PARTS BULLETIN

Models: **17RY and 22RY**

Subject: **Temperature Switch Part Number and Location Change**

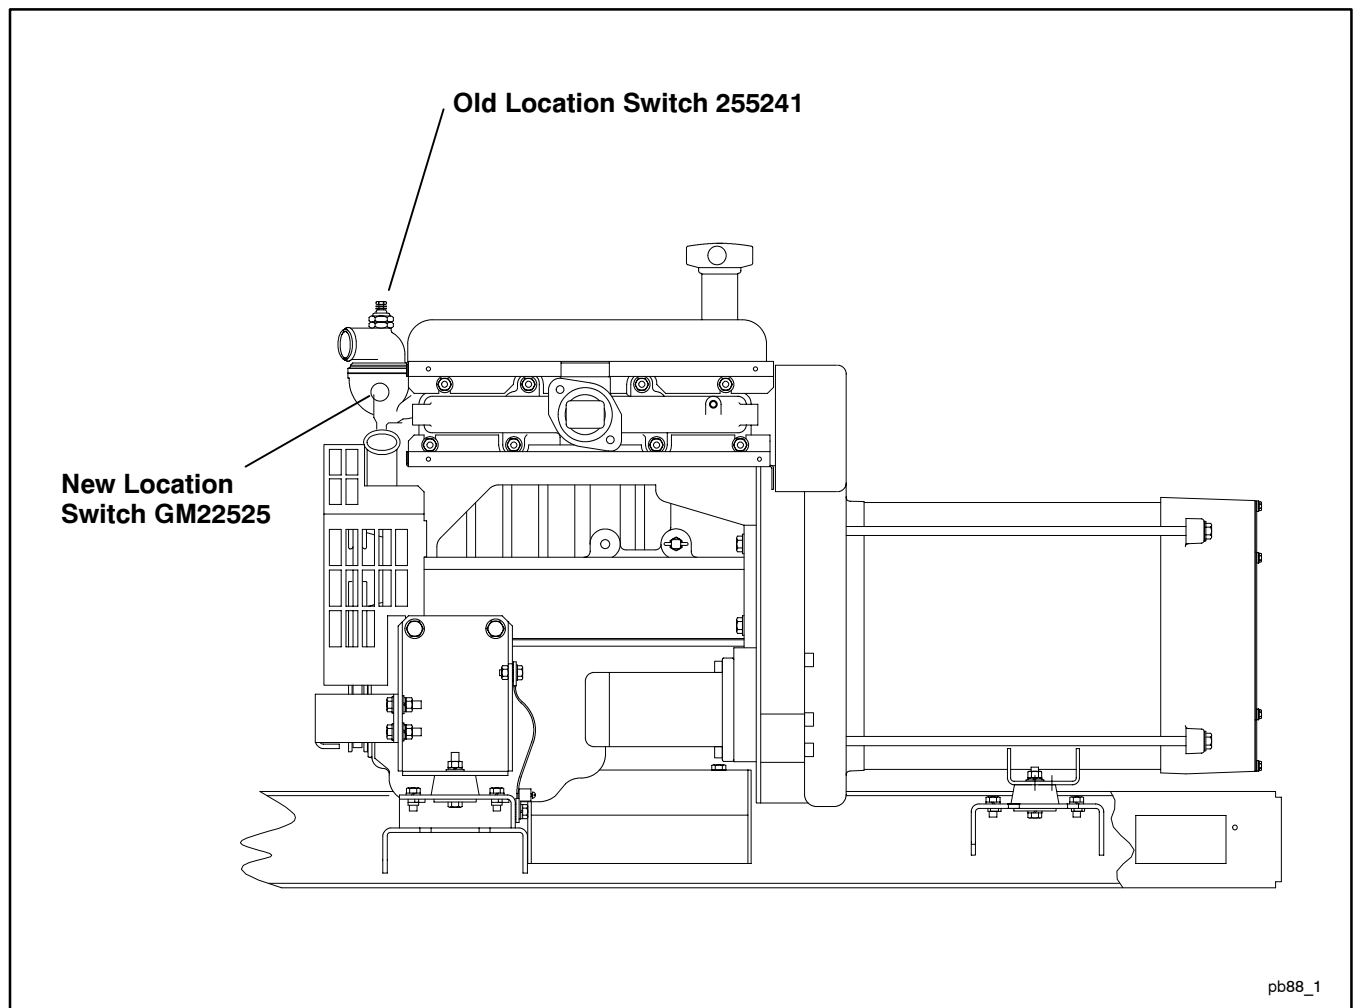
As a product improvement, Kohler has changed the part number and location of the temperature switch on the above models.

If replacing switch part number 255241 in the old location, order switch part number GM22525 and install

it in the new location directly into the cylinder head. The older sender remains in the thermostat housing as a plug.

Please note this change in parts catalog TP-6007 5/01, 17/22RY, page 23, item 47.
